**SUBJECT: Pikeview Quarry, M-1977-211, Technical Revision No. 24
Final reclamation drainage re-design**

REQUEST FOR TECHNICAL REVISION (TR) COVER SHEET

Reference: Technical Revision (TR-23), Pikeview Quarry, M-1977-211

Updates to the reclamation drainage design have been made due to the conditions in the field and the granitic bedrock that will be left in place. This TR contains updated information and is intended to be reviewed with Exhibit G of the Amendment 4 for model input parameters and background information. Below summarizes the additional channels and justification. The channel designs are summarized in Table 1.

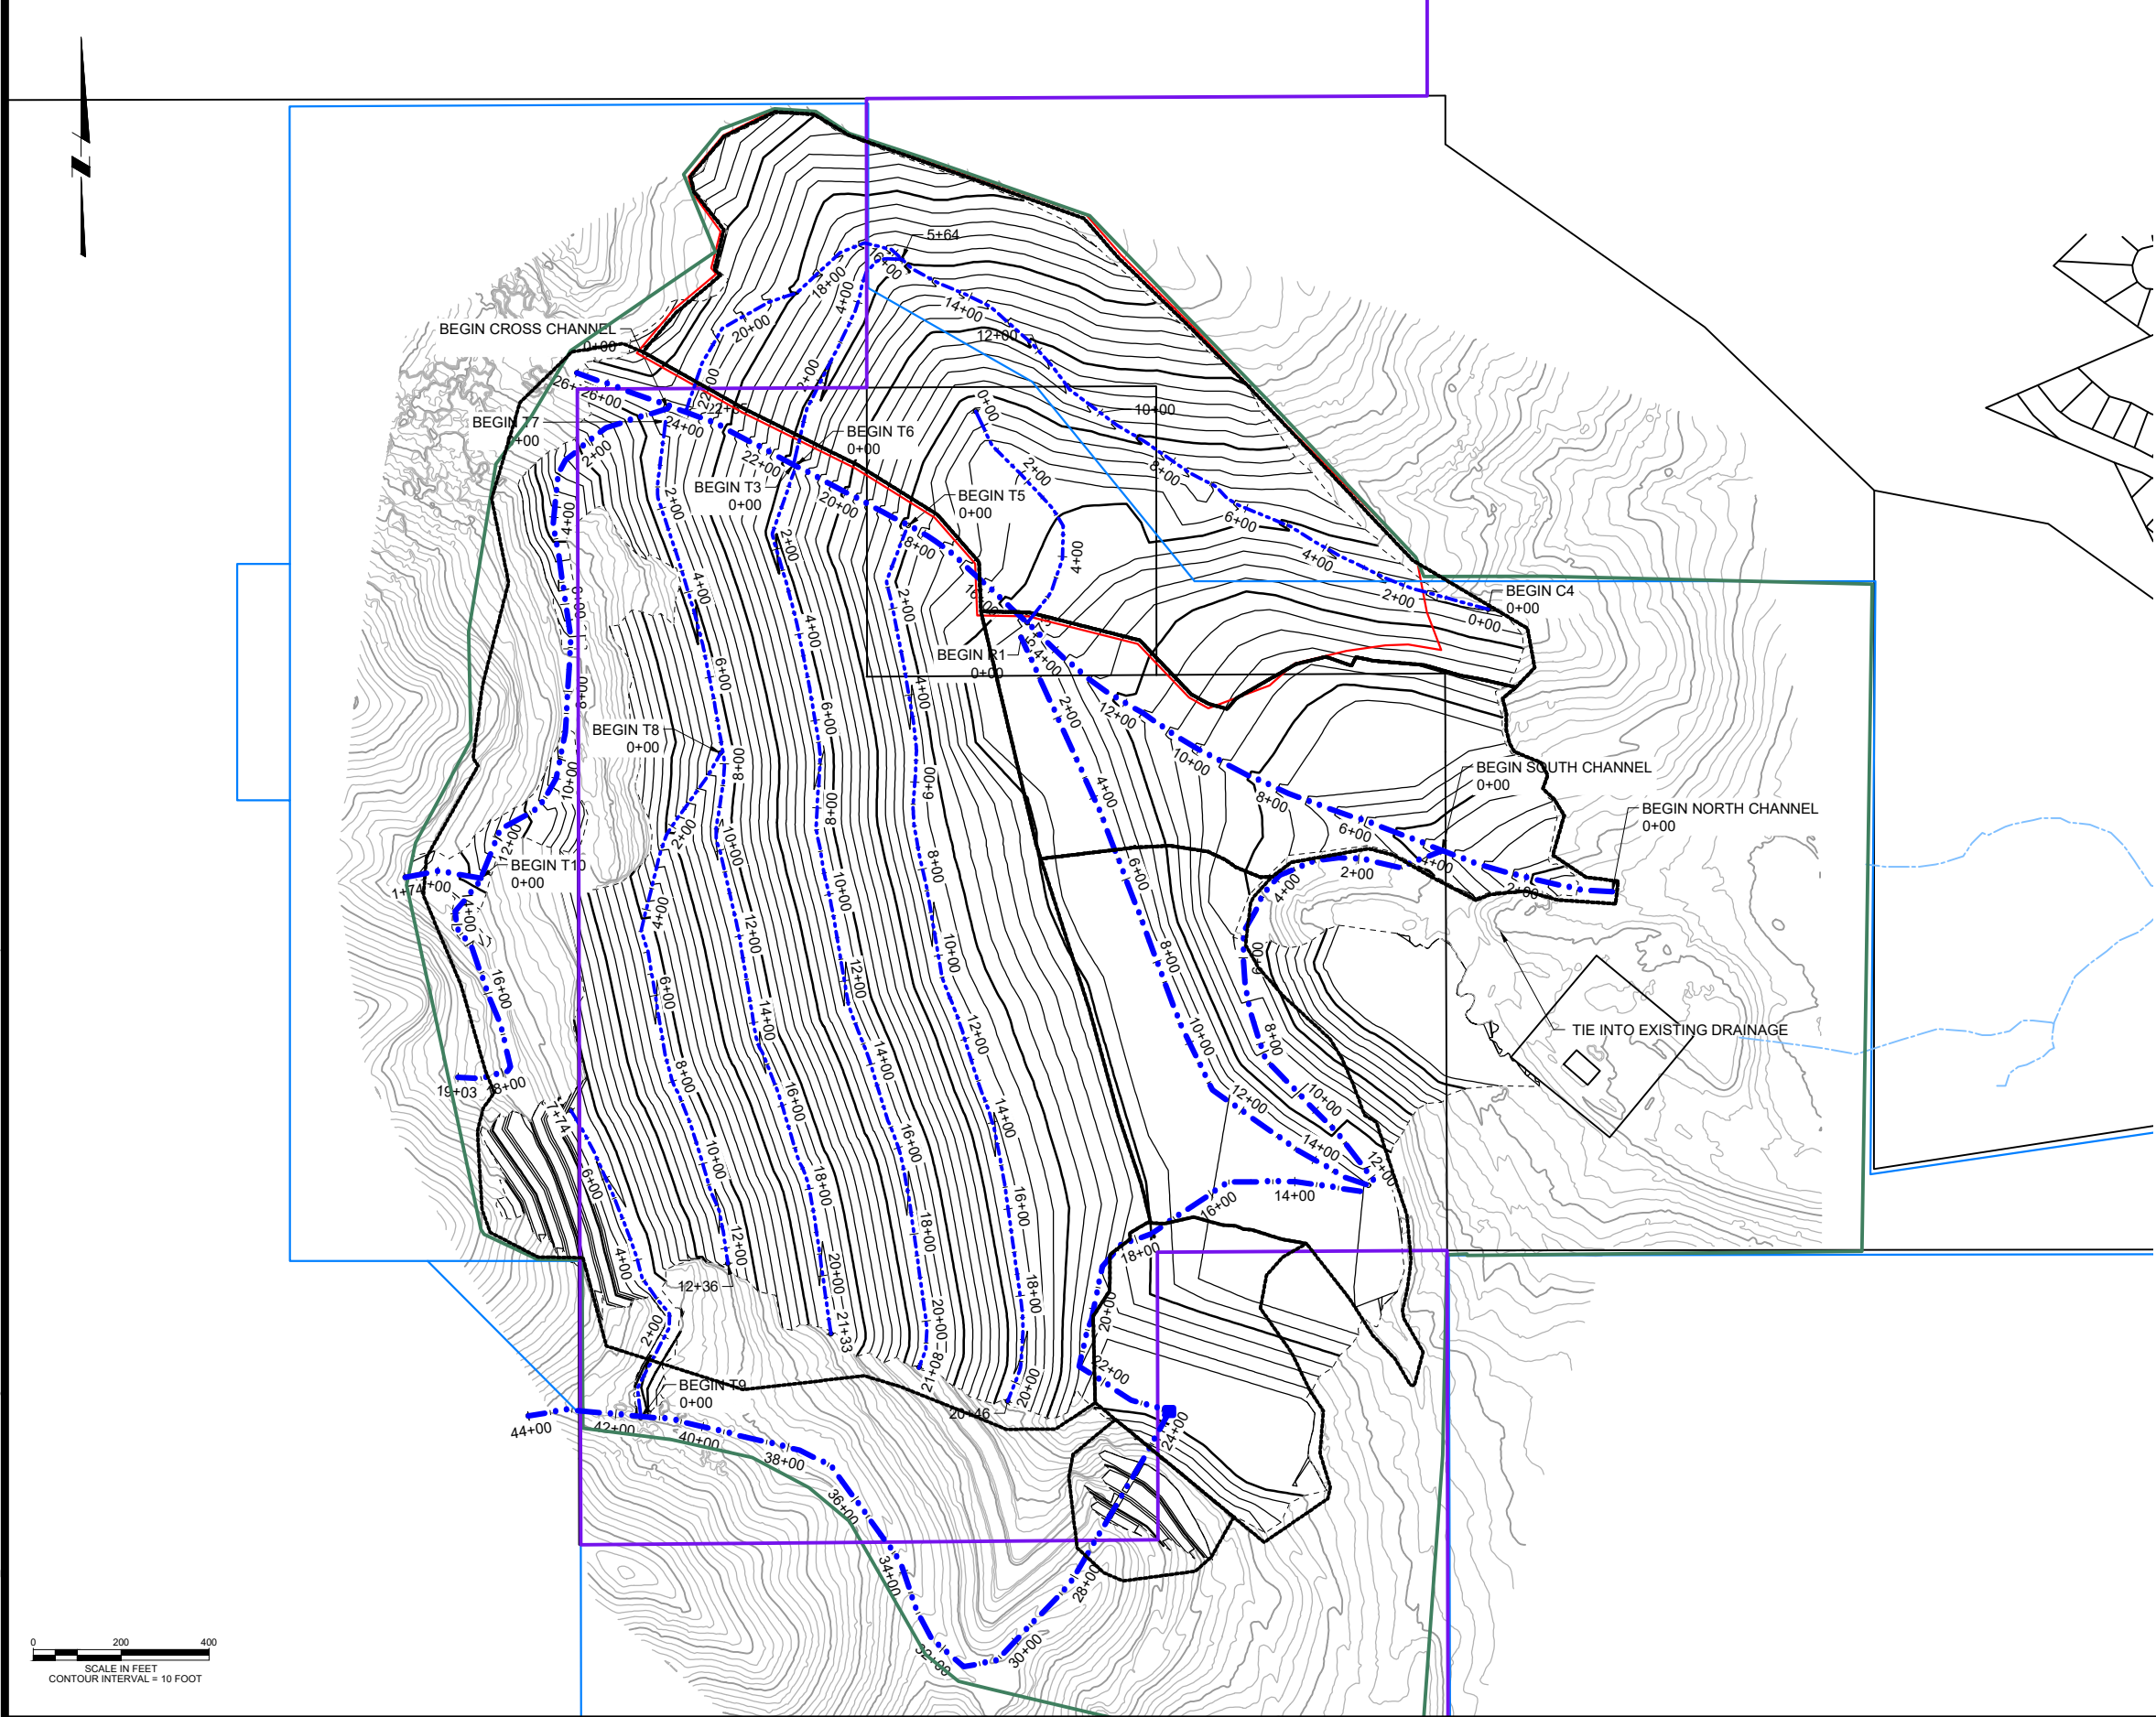
- Cross Channel – This channel routes the flows from the upper area to the main channel. Reclamation construction revealed the presence of competent bedrock that the water needed to be diverted around from the previously approved design. The Cross Channel design has been separated into three sections based on the channel gradient and the calculated design flows.

- Channel T9 – Diverts water collected from the south peak watershed towards the south channel.
- Channel T8 – Due to the rock outcroppings that will remain in place, proposed terrace channel T8 was rerouted to avoid the outcroppings and to connect with terrace channel T7. Terrace channel T8 will have two segments. The upper segment design follows the terrace channel design. The lower/steep segment includes a riprap armored channel that slopes down to terrace channel T7.

- Channel T7 – The alignment of this channel did not change, but the design flows increased due to the additional flows from terrace channel T8. This channel has been divided into an upper and lower section. The upper segment is upstream from the confluence with T8, and the design follows the terrace channel design. The lower segment considers the flows from T8.
